PERMANENT WTC PATH TERMINAL

FINAL ENVIRONMENTAL IMPACT STATEMENT

VOLUME II

THE WORLD TRADE CENTER TRANSPORTATION HUB
Permanent WTC PATH Terminal and Pedestrian Connections
Environmental Review Process
DEIS Comments Summary

Verizon Proposal #3

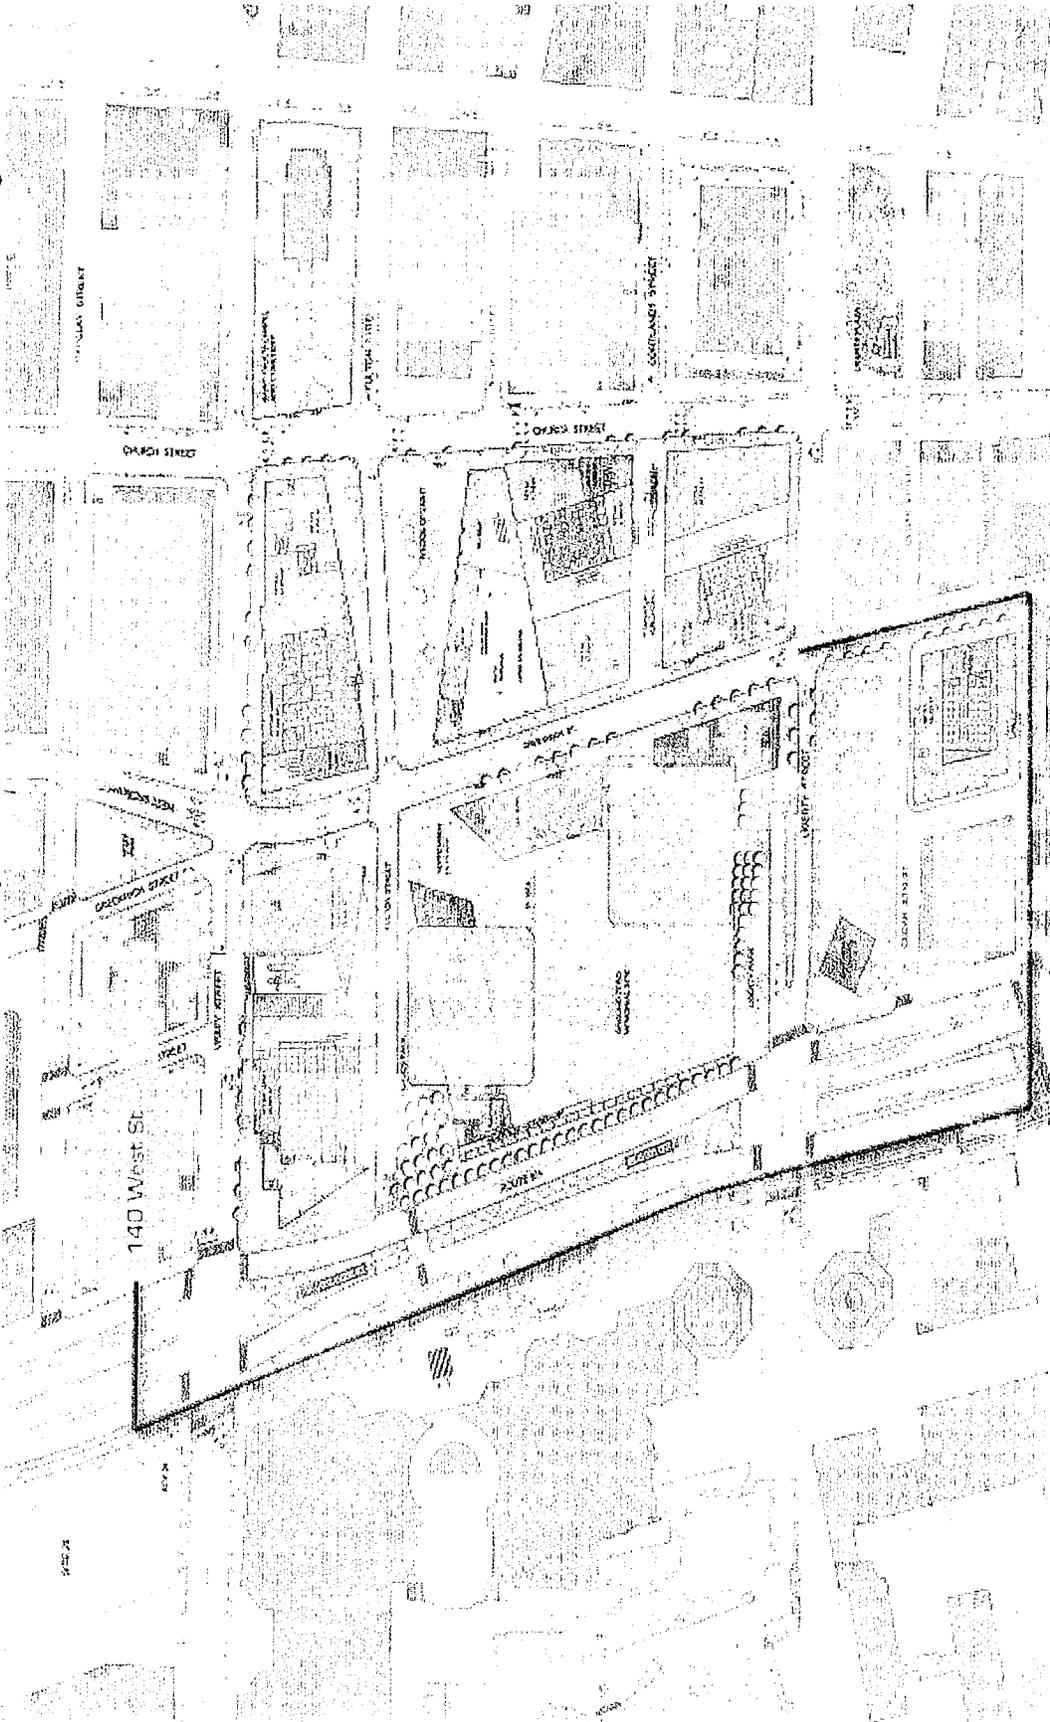
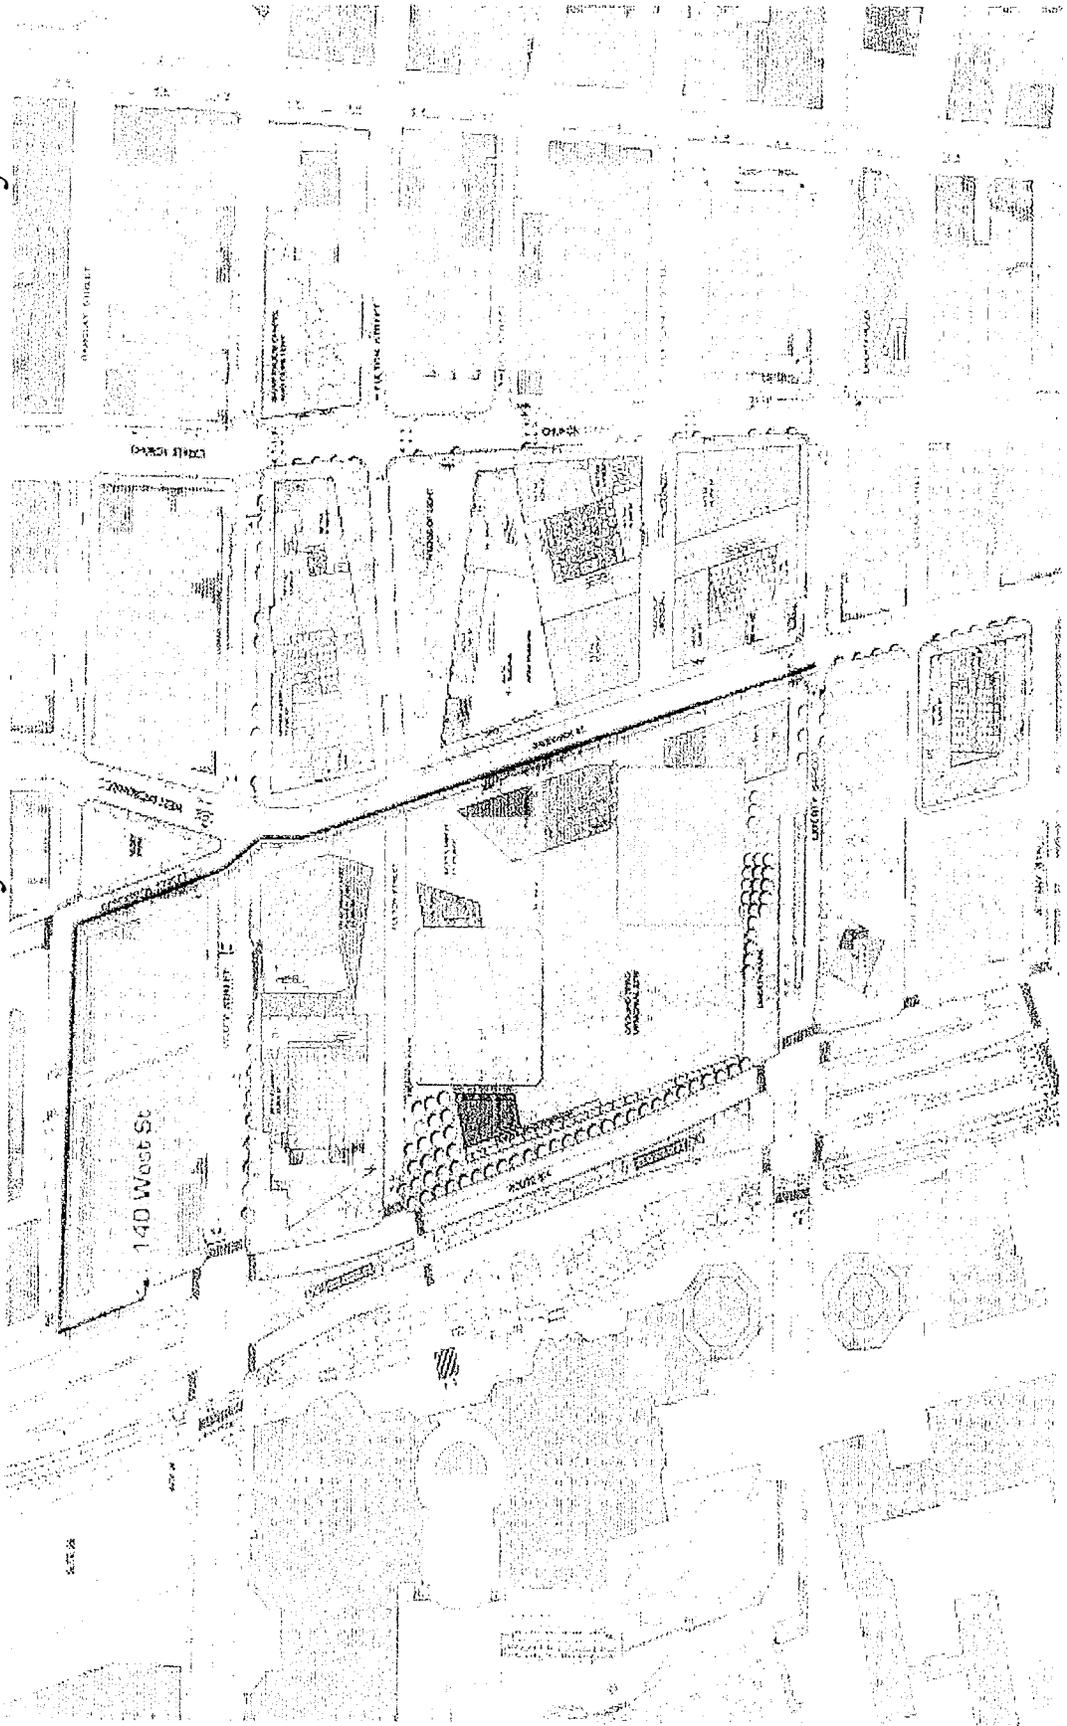
East Side of Route 9A to Barclay St to Greenwich St to Liberty St

Verizon Proposal #2

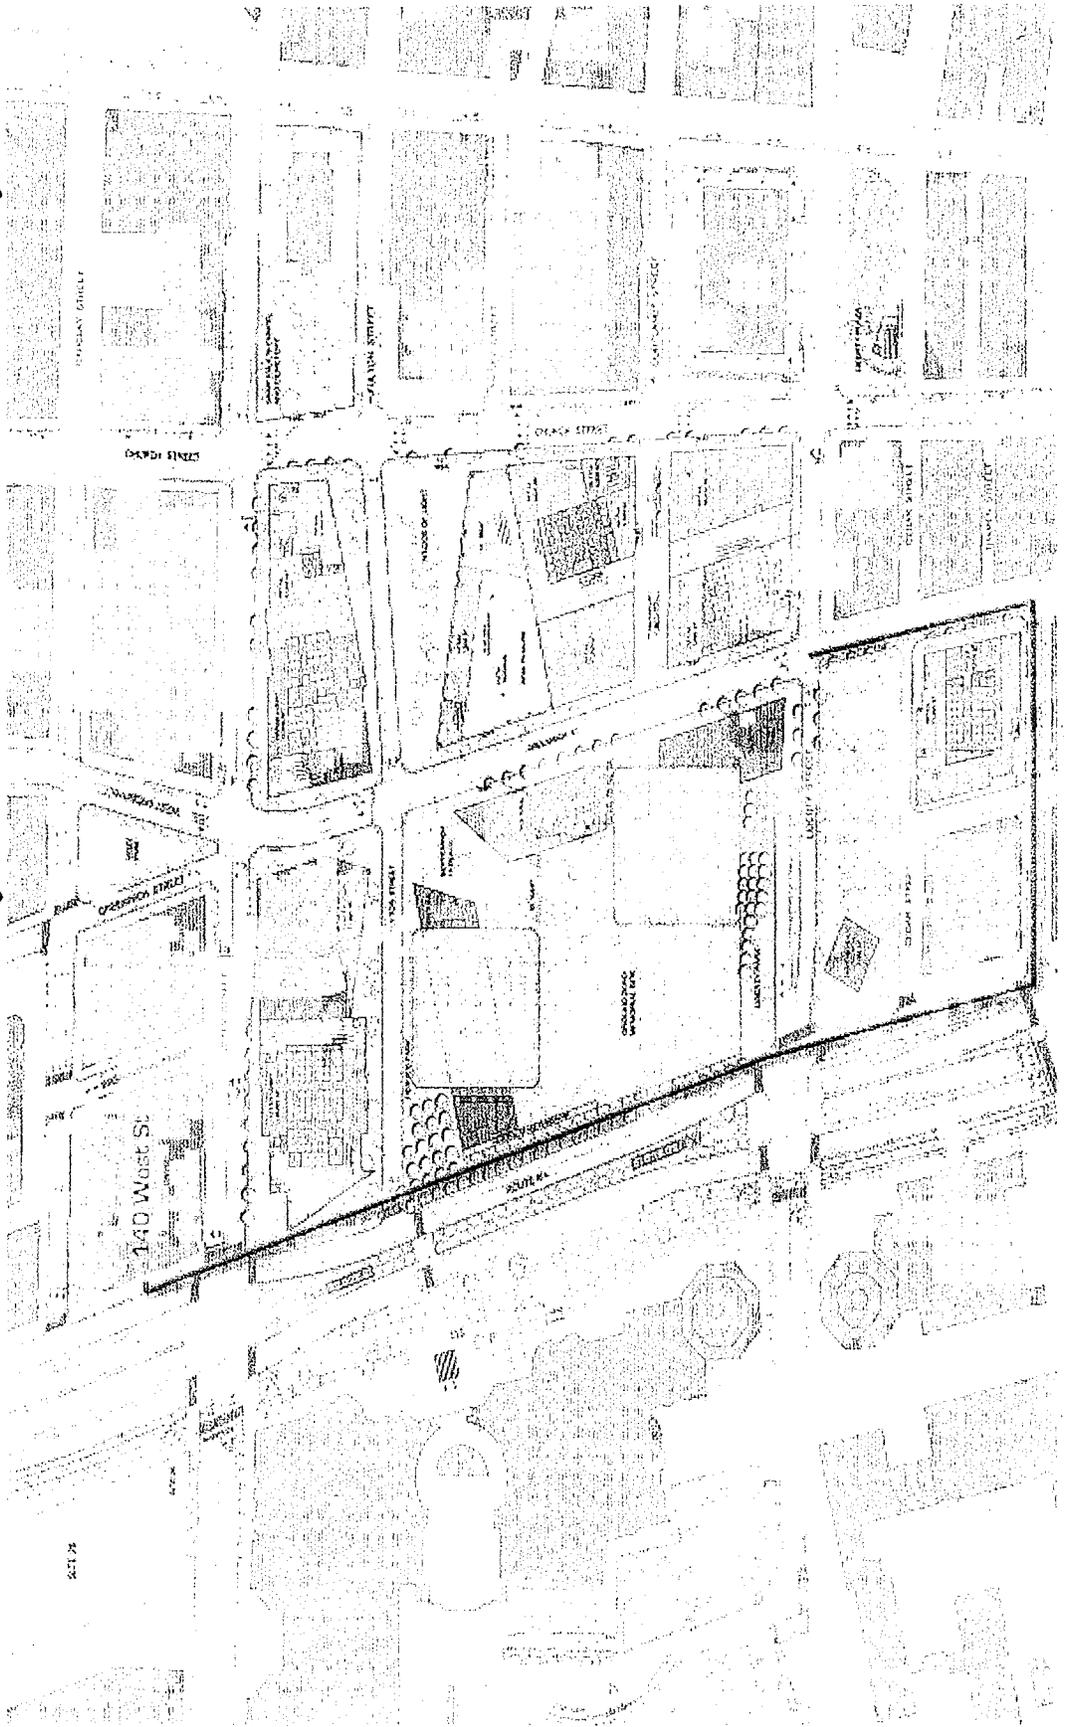
East Side of Route 9A to Albany St to Greenwich St to Liberty St

PATH-Lex Connection Basic Alignment (2.8)

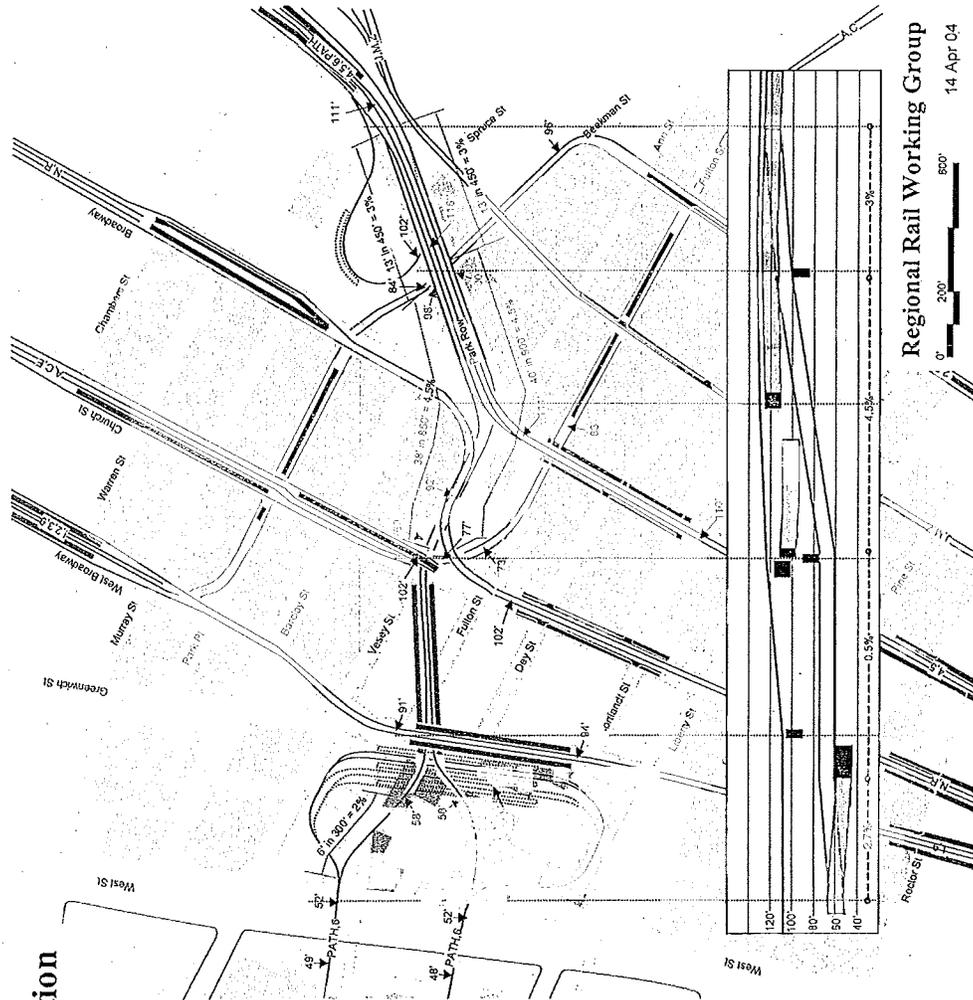
This alignment connects the PATH tracks at the west side of the World Trade Center cellar with the Lexington Avenue local tracks just south of the Brooklyn Bridge - City Hall station. The new tracks rise from the PATH tunnel portals, pass over the tracks and platforms of the temporary PATH station, under the 1 & 9 in Greenwich Street, under the A & C at Church and Vesey Streets, the northbound track passes under the 4 & 5 at Broadway and Park Row, the tracks then rise on either side of the 4 & 5, pass over the 2 & 3 at Beekman Street, sever the loop used by the 6 at City Hall and connect to the local tracks just south of the station.
